Project: Southview Farmhouse, Trowbridge

Subject: Response to LLFA Comments

Reference: 19682-TUM-TN-XXX-0001

Planning App Ref:	PL/2026/01506
Service Ref:	Drainage
Date:	09/07/2026

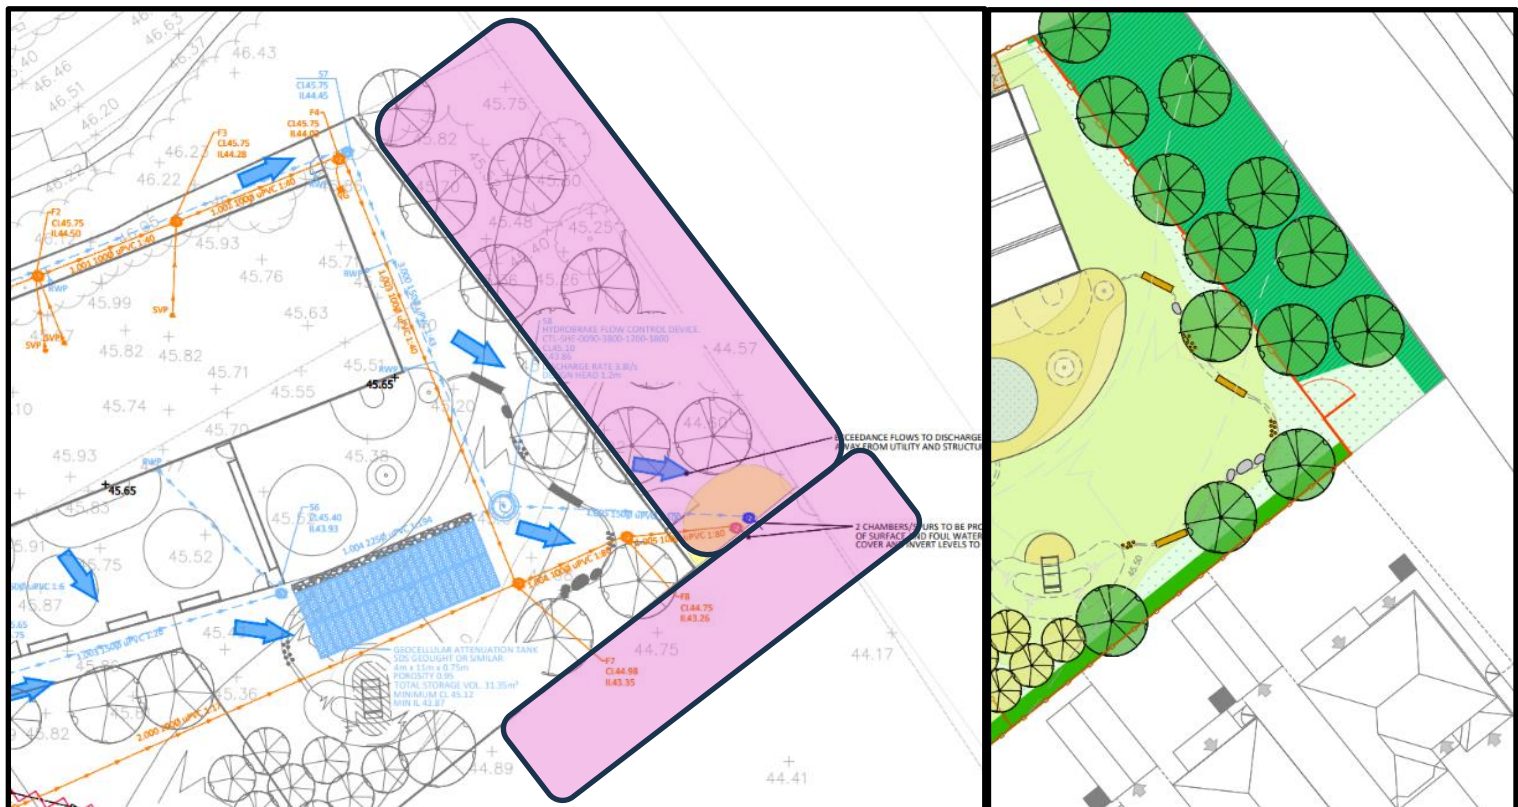
2. Exceedance routing

The applicant has provided comments to justify the proposed exceedance strategy; however, it appears that the underlying concern has been misunderstood. While the LLFA acknowledges that ground levels within Areas 1 and 2 are not proposed to change, the increase in impermeable area across the site, together with the need to consider potential drainage system failure scenarios, means that overland flow volumes passing through these areas may increase.

Given that these exceedance flows are currently directed off-site towards neighbouring development and existing infrastructure, the proposed arrangement is not acceptable. The applicant should therefore propose measures to intercept, manage, and contain flows within the site boundary to ensure that no increased flood risk or adverse impact is imposed on adjacent land, property, or infrastructure.

3. Construction phasing

In the event where the Southview Farm development may be constructed ahead of the Barratt Redrow development, the applicant proposes to discharge surface water via a combination of temporary ditch conveyance and overland flow routes to the culvert beneath the railway within the site. This approach is not considered acceptable by the LLFA.

There is uncertainty regarding how overland exceedance flows will be directed towards the culvert, raising concerns that flows may not be effectively conveyed and could increase flood risk to the existing railway track.

There is also uncertainty regarding how surface water drainage will be managed during the Barratt Redrow construction phase, which may result in exceedance flows not being adequately controlled, increasing flood risk to the railway and adjacent development.

The LLFA considers that a more robust and formalised drainage solution is required to ensure discharge from Southview Farm is properly conveyed to the culvert in a controlled manner.

The applicant would also be required to obtain Land Drainage Consent, demonstrate sufficient culvert capacity, and secure agreement with Barratt Redrow to ensure drainage is maintained

during construction, until connection to their drainage network is completed in accordance with the approved strategy.

Refer to the contours shown in the figure below, which illustrate the site topography. (Source: SCALGO).

Wiltshire LLFA Comment	Tumu Response
2. The applicant has provided comments to justify the proposed exceedance strategy; however, it appears that the underlying concern has been misunderstood. While the LLFA acknowledges that ground levels within Areas 1 and 2 are not proposed to change, the increase in impermeable area across the site, together with the need to consider potential drainage system failure scenarios, means that overland flow volumes passing through these areas may increase. Given that these exceedances flows are currently directed off-site towards neighbouring development and existing infrastructure, the proposed arrangement is not acceptable. The applicant should therefore propose measures to intercept, manage, and contain flows within the site boundary to ensure that no increased flood risk or adverse impact is imposed on adjacent land, property, or infrastructure.	An extract from the Wiltshire LLFA comments dated 09/07/2026 has been reproduced below. The areas highlighted in pink have been labelled Area 1 and Area 2 for ease of reference.  Area 2 lies outside the application site boundary and falls within the Barratt Redrow development site. As this area is outside our client's control and is proposed to be redeveloped as part of the Barratt Redrow scheme, responsibility for the management of surface water runoff within Area 2 rests with Barratt Redrow. The drainage has been designed to attenuate all surface water from the development within the drainage system for all storms up to and including the 1% AEP with a 45% allowance for climate change ie The exceedance routes are used for rainfall events in excess of the 1% AEP with a 45% allowance for climate change. CIRIA C635 (<i>Designing for Exceedance in Urban Drainage</i>) provides guidance on the safe routing and management of exceedance flows. We are not aware of any requirement within either the National Standards for Sustainable Drainage Systems or CIRIA guidance that requires all exceedance flows from rainfall events exceeding the 1% AEP event (including climate change) to be contained entirely within the site boundary. The proposed exceedance routes shown replicate the current exceedance flow routes. Surface water currently discharges from the existing farmhouse eastwards due to the topography of the land. By providing 1 no. tank and 2 no. permeable paving sub base that collects and attenuates flows up to the 1% AEP event + 45 % climate change, we are providing a betterment on the existing scenario. However, as the client wishes to progress without further rebuttal, it is proposed to introduce a 500mm high bund on the south east corner of the site. The total exceedance storage area is 91m² with an approximate storage volume of 22m³. The bund will intercept and hold any exceedance flows temporarily, before percolation into the ground. Refer to Appendix C for the updated Drainage Strategy Drawing.

Wiltshire LLFA Comment	Tumu Response
3. In the event where the Southview Farm development may be constructed ahead of the Barratt Redrow development, the applicant proposes to discharge surface water via a combination of temporary ditch conveyance and overland flow routes to the culvert beneath the railway within the site. This approach is not considered acceptable by the LLFA. There is uncertainty regarding how overland exceedance flows will be directed towards the culvert, raising concerns that flows may not be effectively conveyed and could increase flood risk to the existing railway track. There is also uncertainty regarding how surface water drainage will be managed during the Barratt Redrow construction phase, which may result in exceedance flows not being adequately controlled, increasing flood risk to the railway and adjacent development. The LLFA considers that a more robust and formalised drainage solution is required to ensure discharge from Southview Farm is properly conveyed to the culvert in a controlled manner. The applicant would also be required to obtain Land Drainage Consent, demonstrate sufficient culvert capacity, and secure agreement with Barratt Redrow to ensure drainage is maintained during construction, until connection to their drainage network is completed in accordance with the approved strategy.	The temporary surface water arrangement has been amended. In the event that the South View Farmhouse development is completed prior to the Redrow development, the discharge of surface water will temporarily be discharged to the ditch on the eastern side of the southern field. Refer to Appendix C for the Temporary Drainage Layout. Surface water will be conveyed by a ditch before discharge at a maximum of 3.8l/s for all storms up to and including the 1% AEP with an allowance for climate change. It should be noted that the development proposed to discharge to this ditch in the previously consented application, PL/2023/11008. Under no circumstances should infilling of this ditch take place downstream of the temporary connection point, prior to the provision of a connection to the Redrow surface water drainage network, and it should be accounted for within Redrow's construction sequencing.
